351-53 New South Head Rd
Double Bay NSW 2028

Demolition Plan

REV	DATE	AMENDMENT
B	4/7/19	Clarification for Council
C	26/11/19	Revised Development Application
D	22/3/21	Revised for Council meeting
E	24/5/21	Issue d for Section 34 conference
F	18/6/21	Section 34 conference progress update
G	14/7/21	Section 34 Agreement

DRAWING TITLE			
Ground Floor Plan			
JOB NO	DRAWN	SCALE	DRAWING NO.
18.41	AR/BD	1:200 @ A3	DA 2.102
DATE	CHECKED	PLOT DATE	REVISION
Sept. 18 PT		14/7/21	G

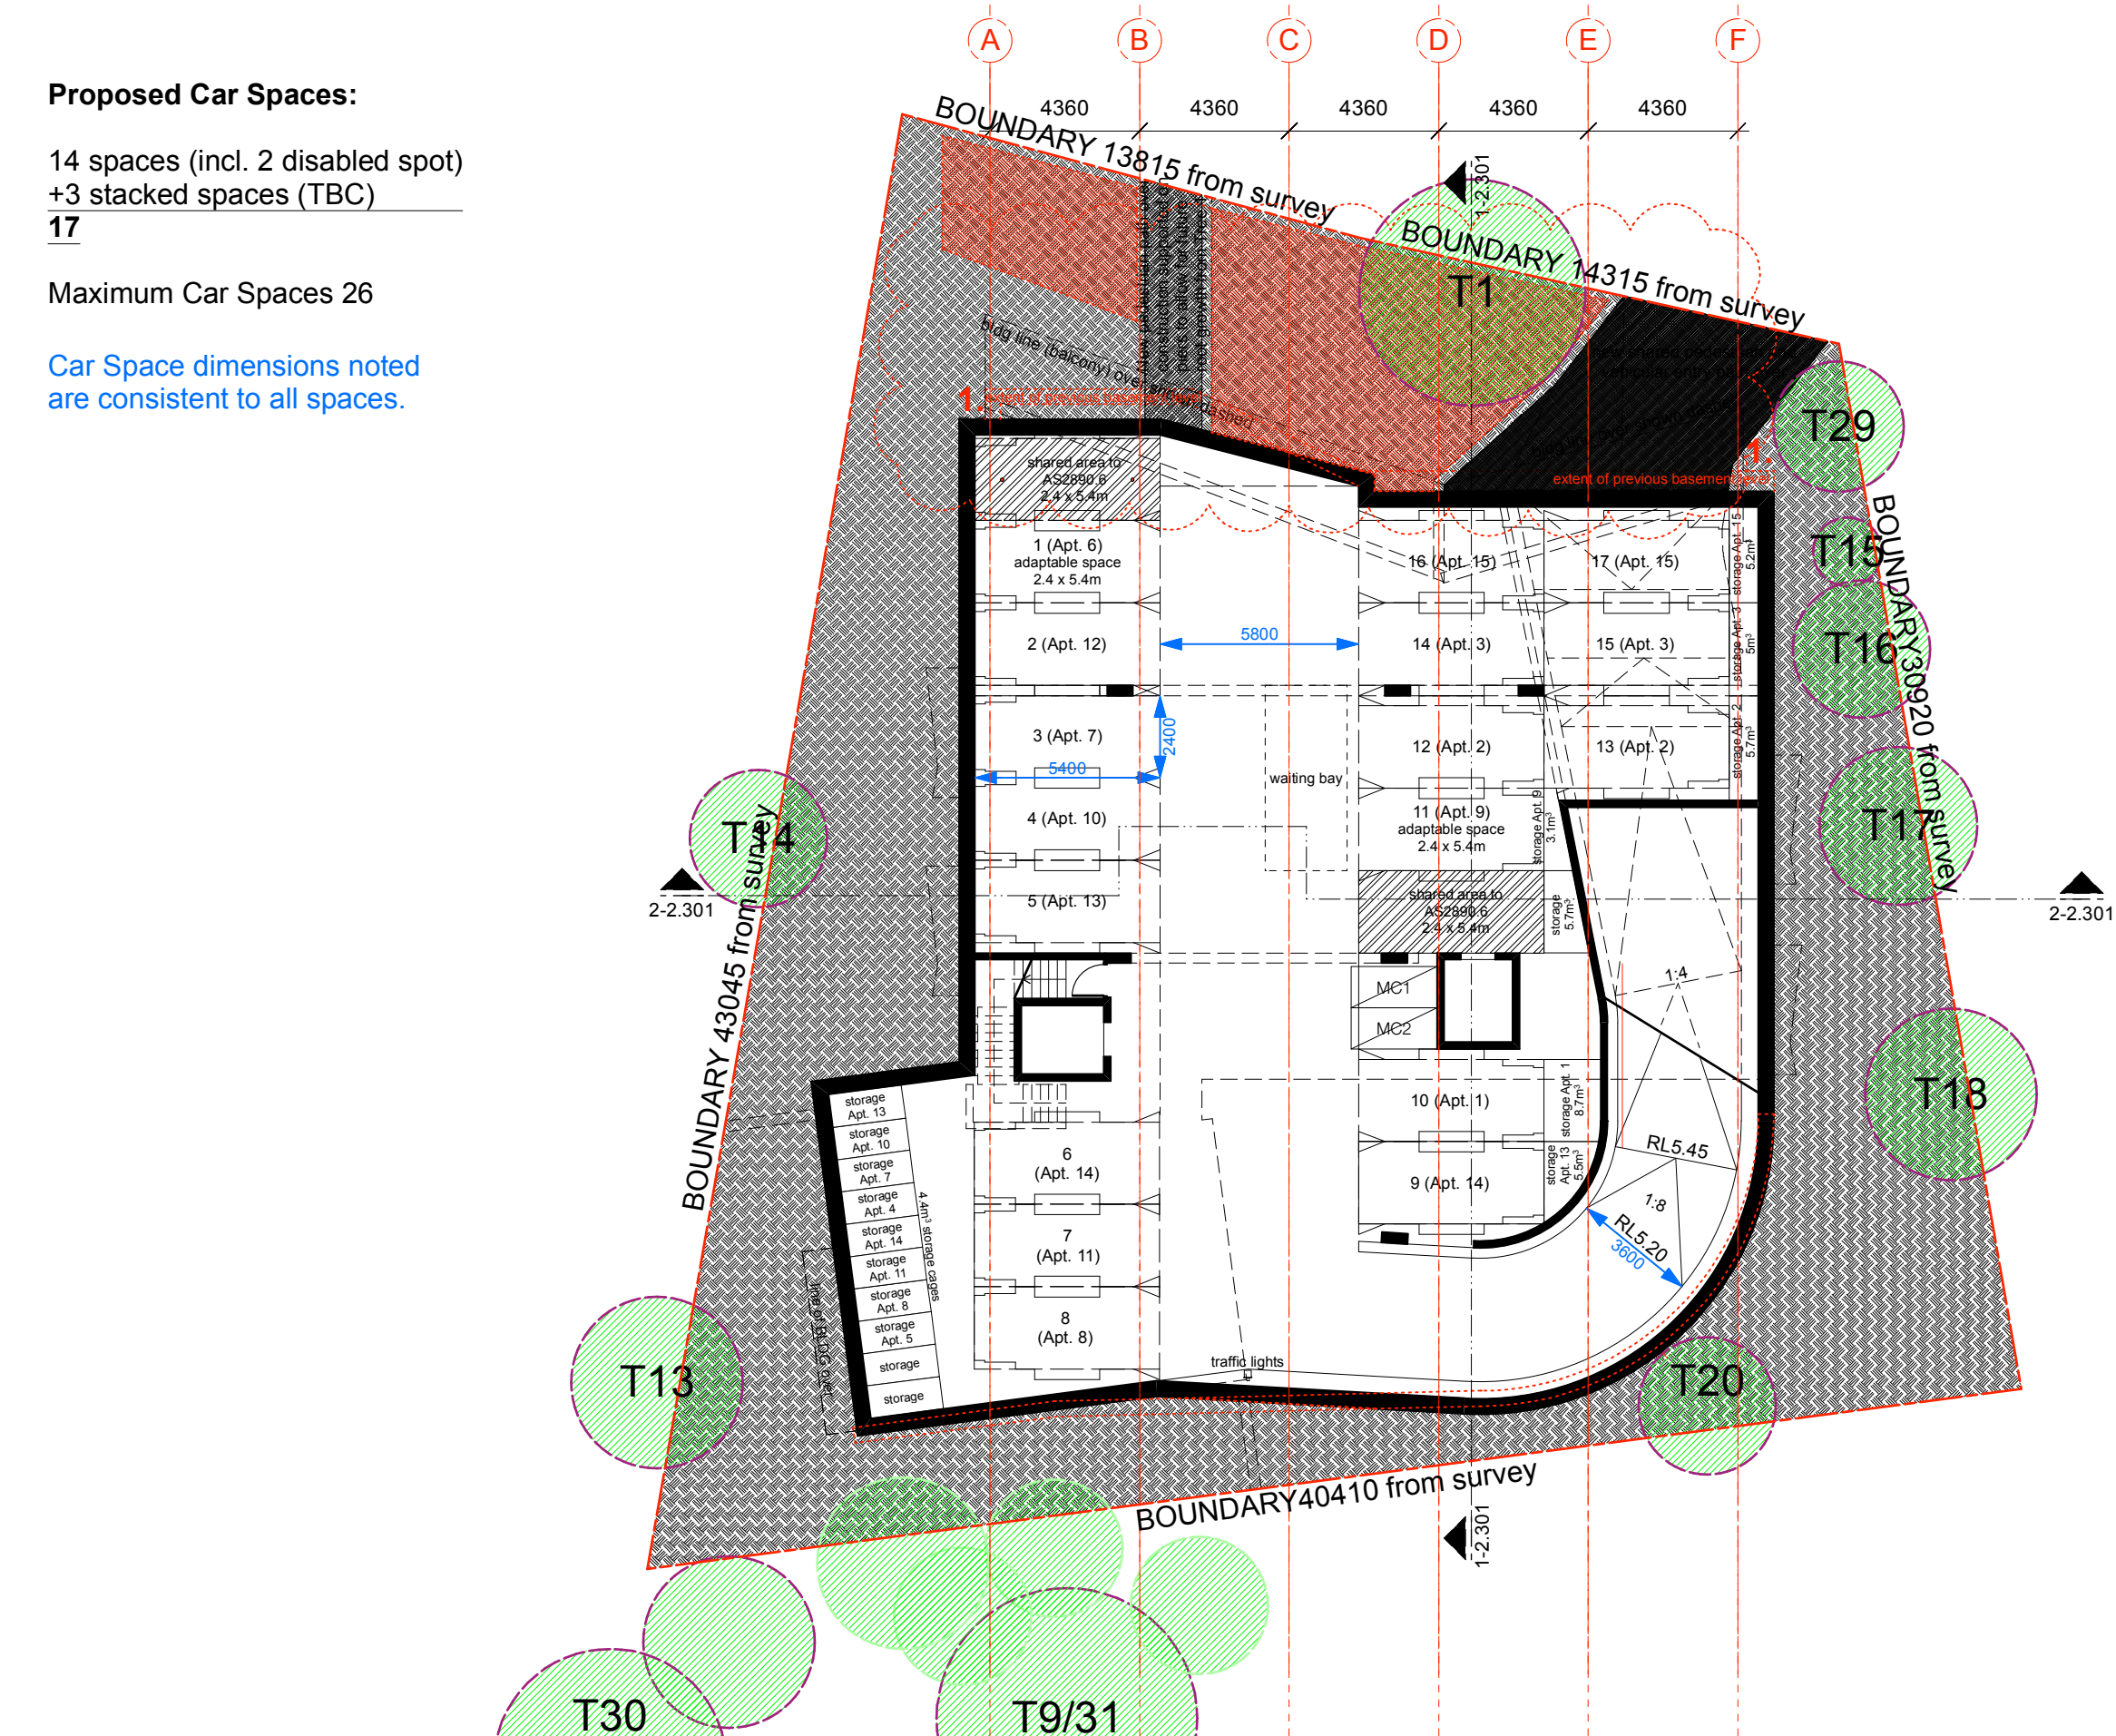
Note:
1. Front setback increased

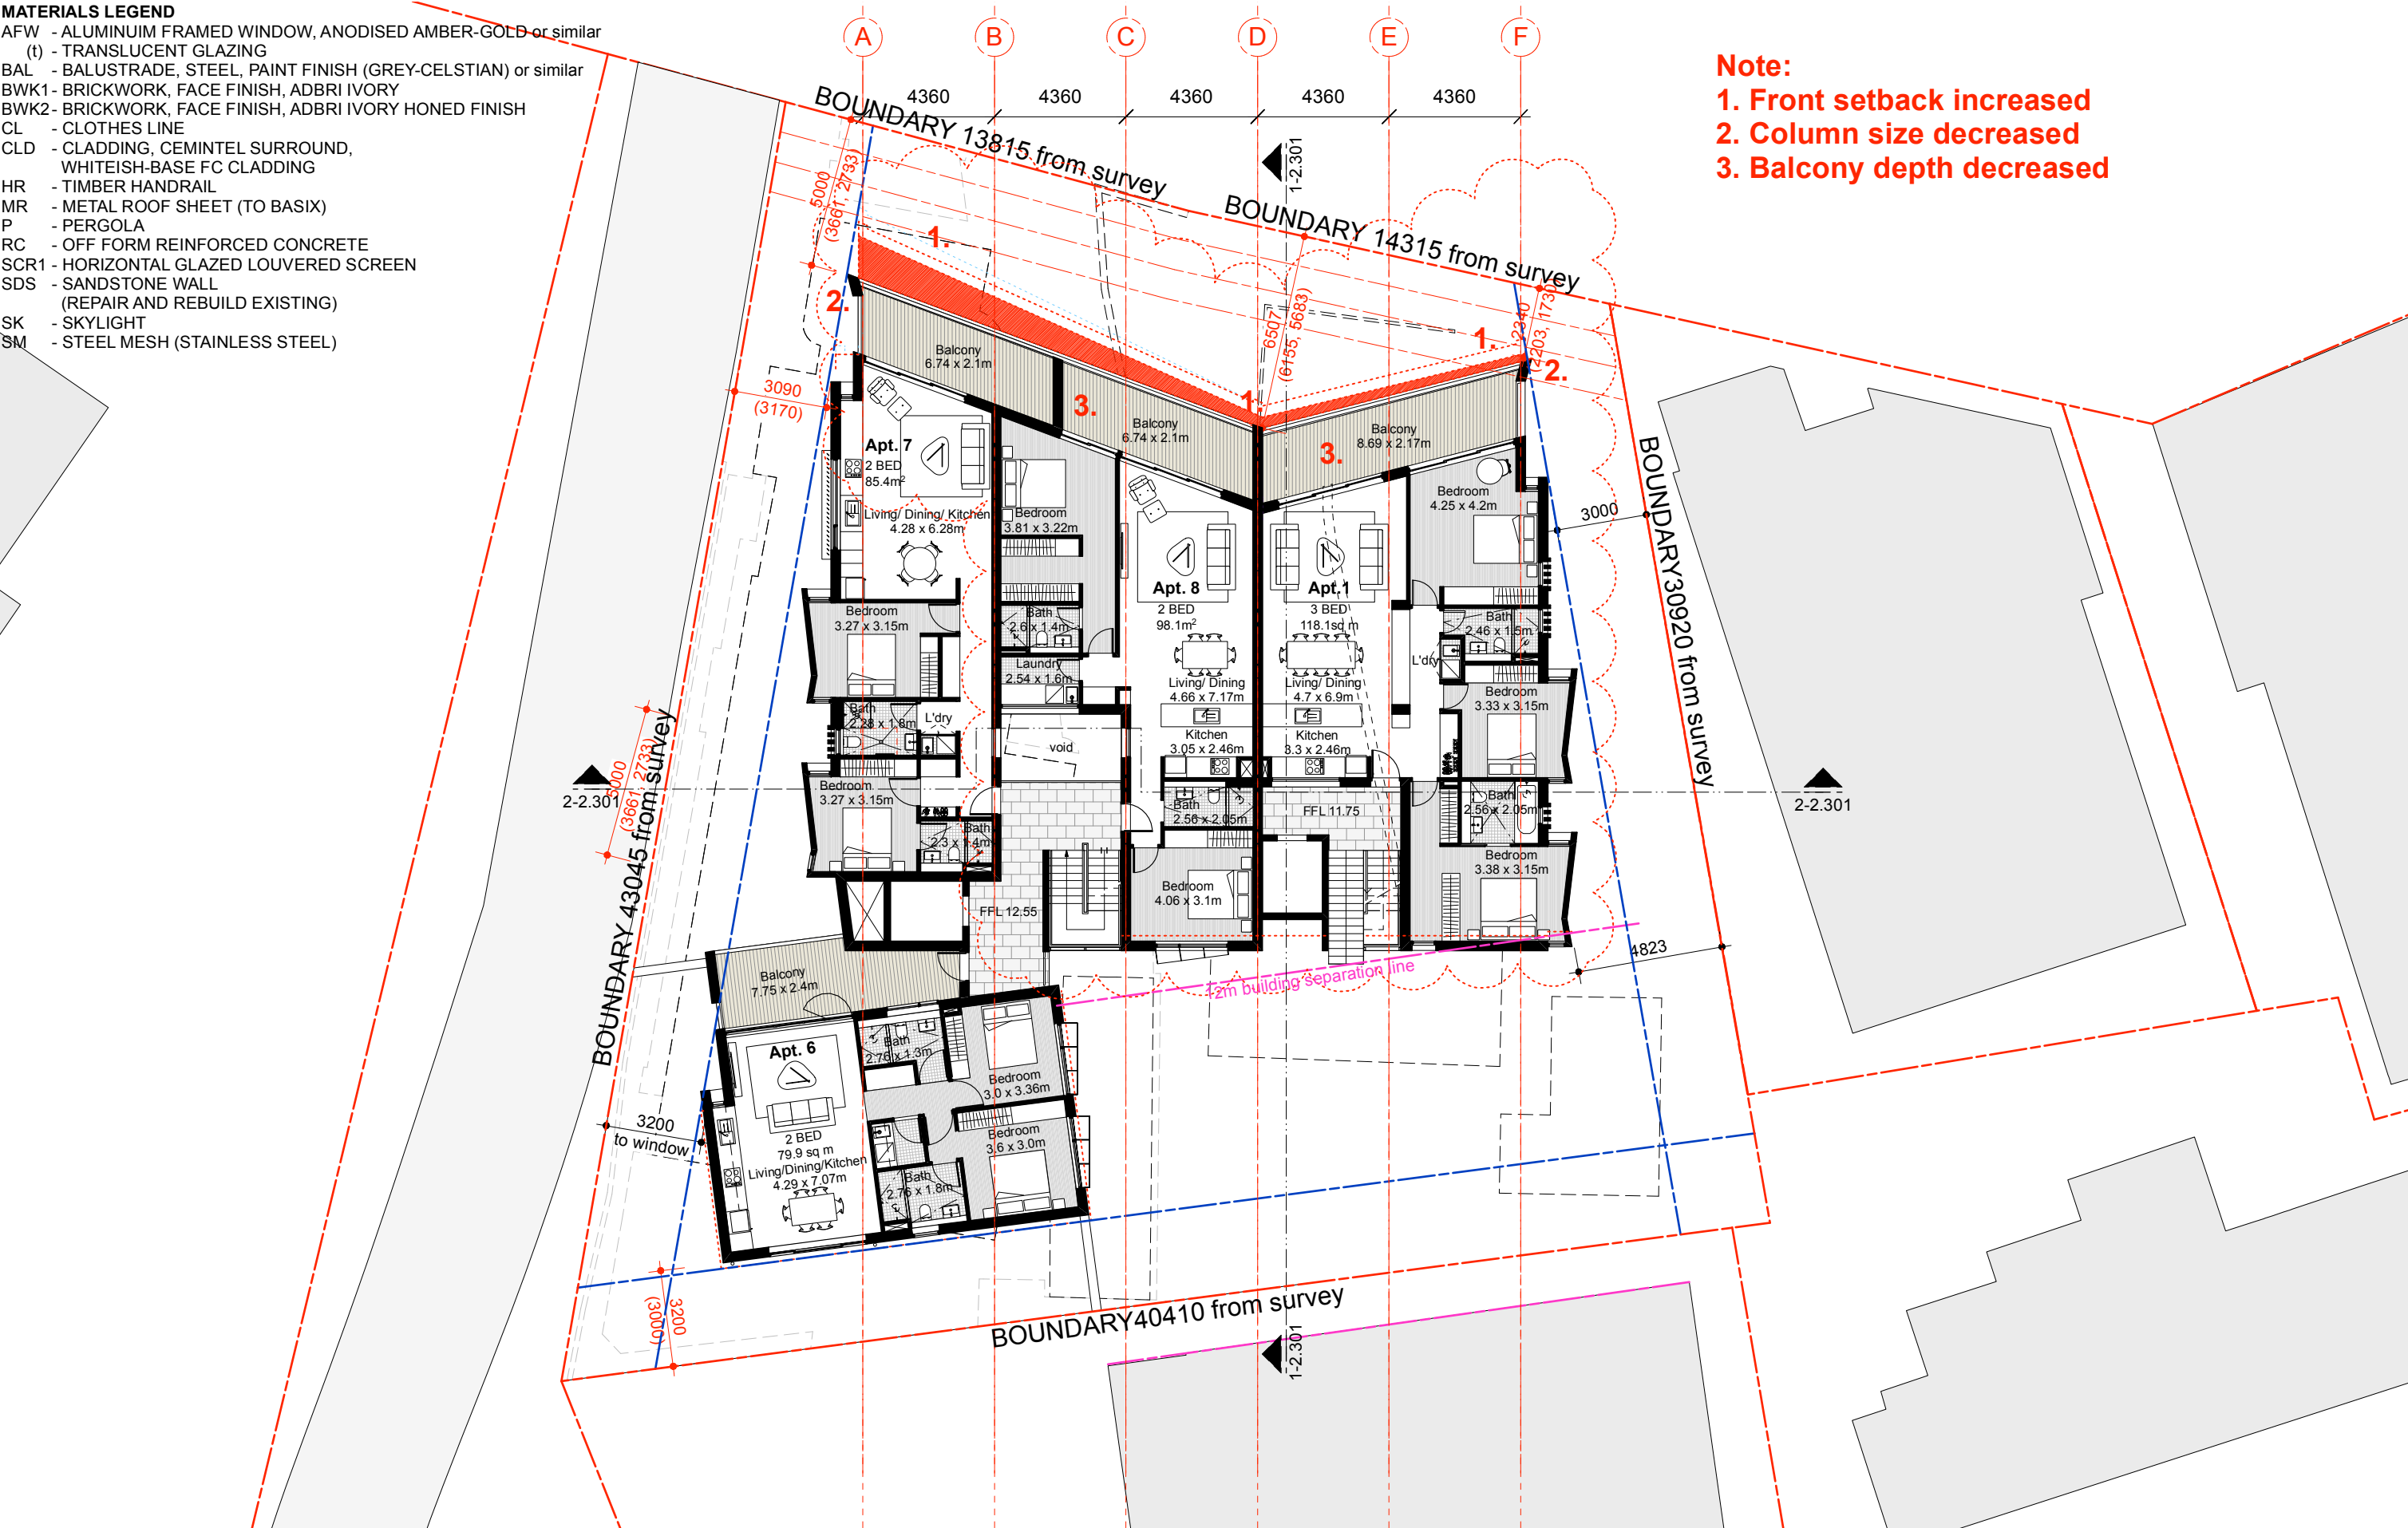
- 1. Front setback increased**
- 2. Blade walls and columns removed**

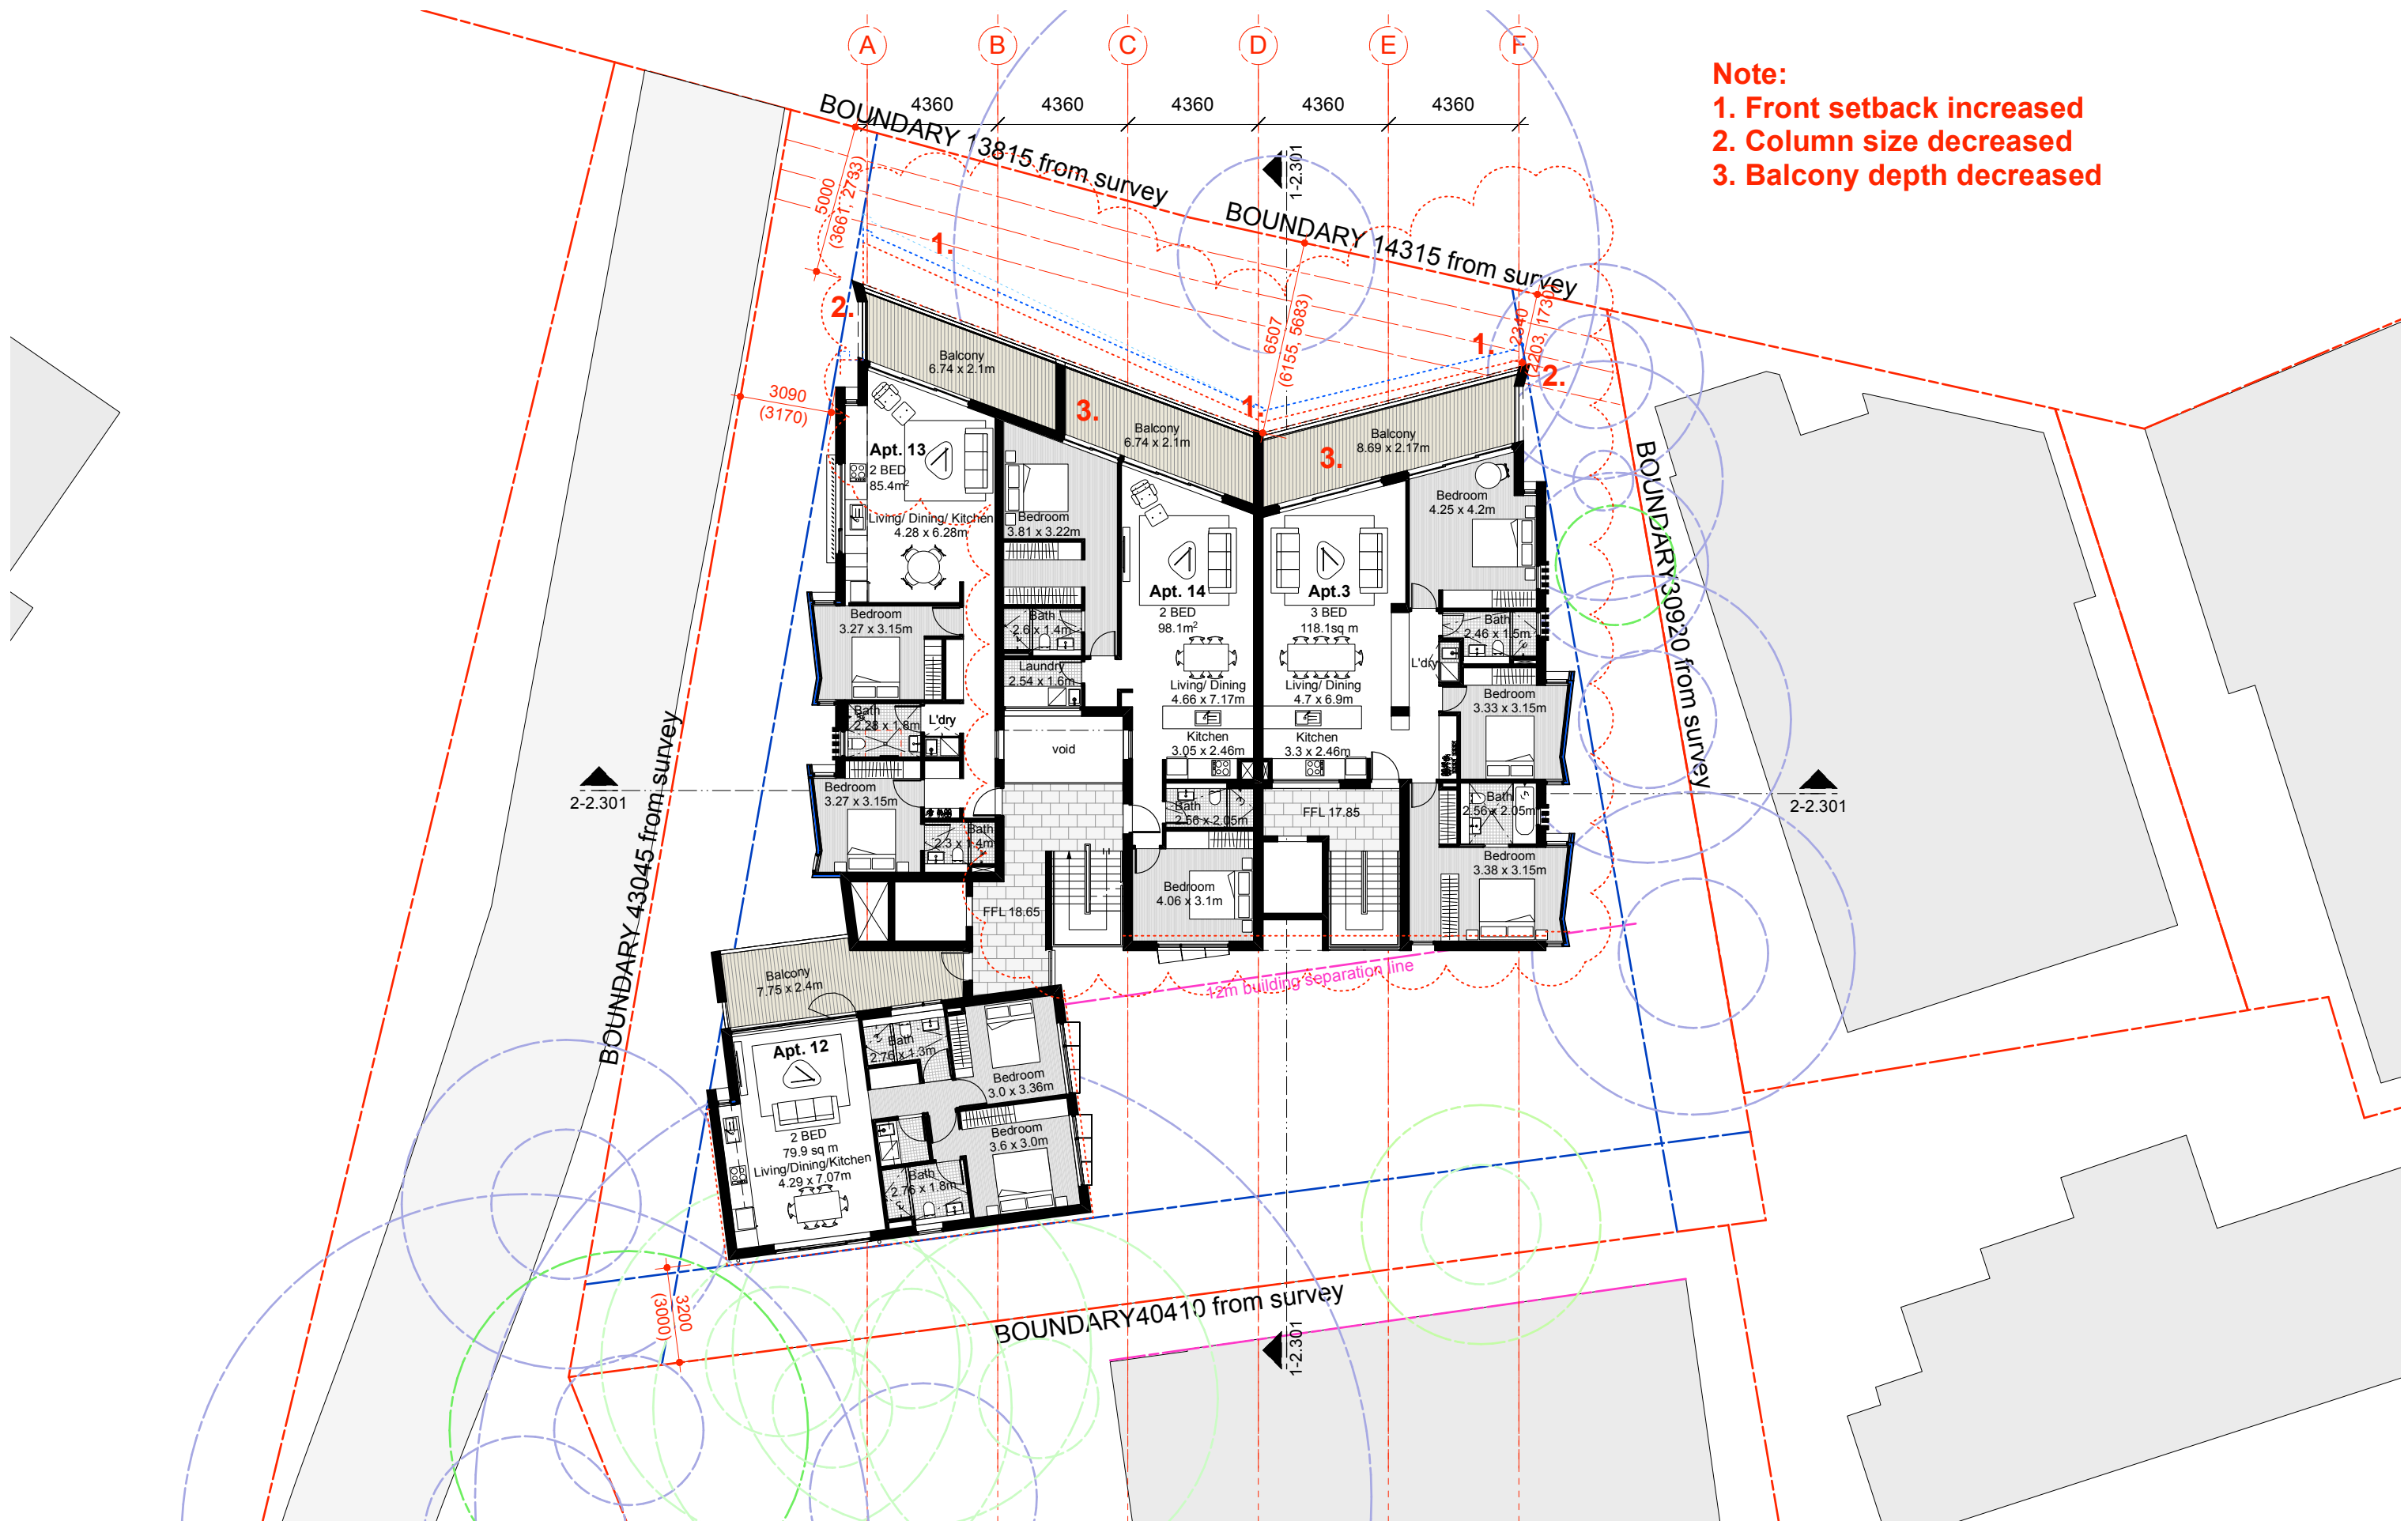
Note:
1. Front setback increased
2. Column size decreased
3. Balcony depth decreased
